Informal document GRPE-82-22  
82<sup>nd</sup> GRPE, 12-15 January 2021  
Agenda item 4(a)

### **Proposal for a new series of amendments to UN Regulation No. 49 (Emissions of compression ignition and positive ignition (LPG and CNG) engines)**

#### **Submitted by the European Commission\***

Figure 12

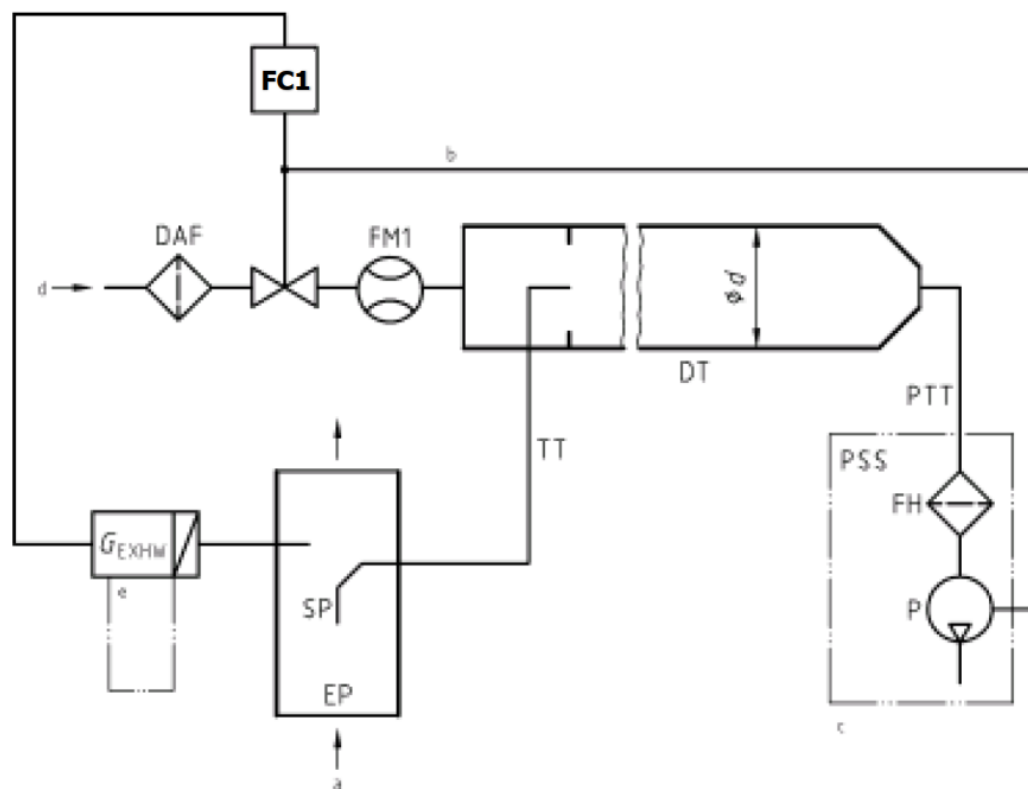
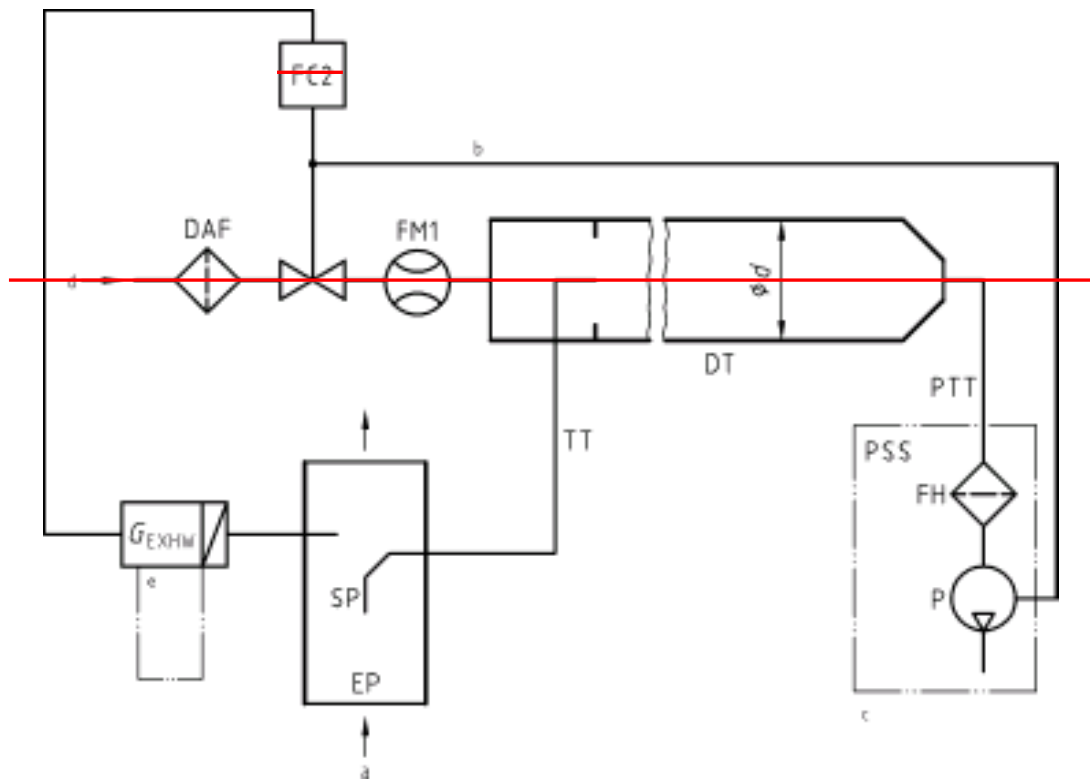
Paragraph A.2.2.1., amend to read:

**Scheme of partial flow dilution system (total sampling type)**

a = exhaust

b = optional

c = details see Figure 16

**Figure 1**  
**Example of a PM number analyser setup**

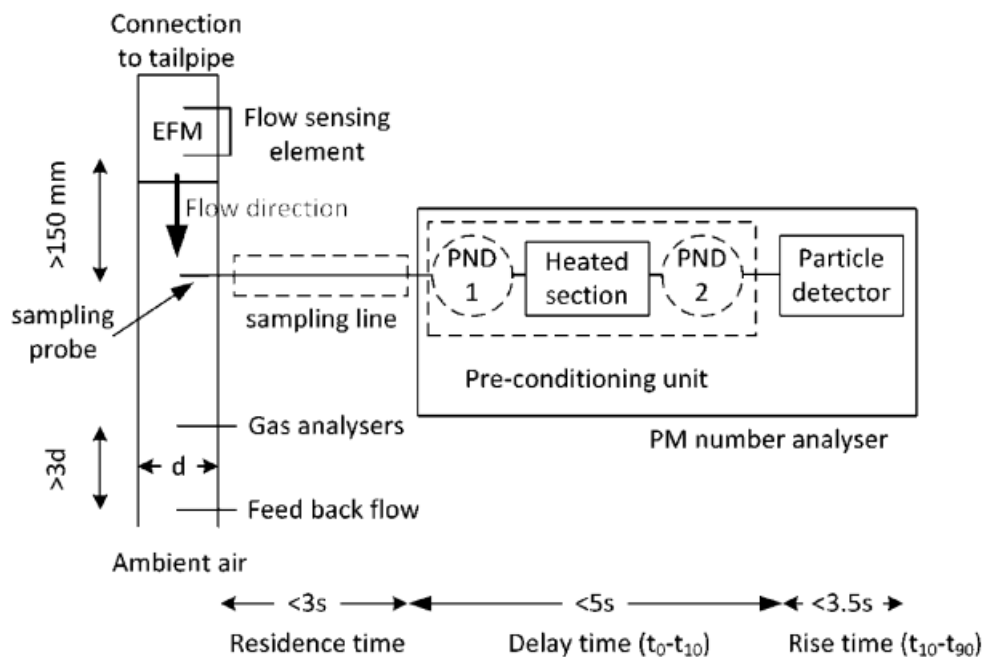
**A.2.2.5.1.1. The PM number analyser shall consist of a pre-conditioning unit and a particle detector (see Figure 1). The particle detector may also pre-condition the aerosol. The analyser's sensitivity to shocks, vibrations, aging, variations in temperature and air pressure, electromagnetic interferences and other things that could affect the operation of the vehicle or the analyser shall be kept to a minimum as far as possible and shall be clearly stated in the supporting documentation produced by the instrument manufacturer. The PM number analyser shall fulfil the requirements of this Regulation and the specifications of the instrument manufacturer.**

**Notes:** dotted lines depict optional parts; EFM means Exhaust mass Flow Meter; d means inner diameter ; PND means PM Number Diluter
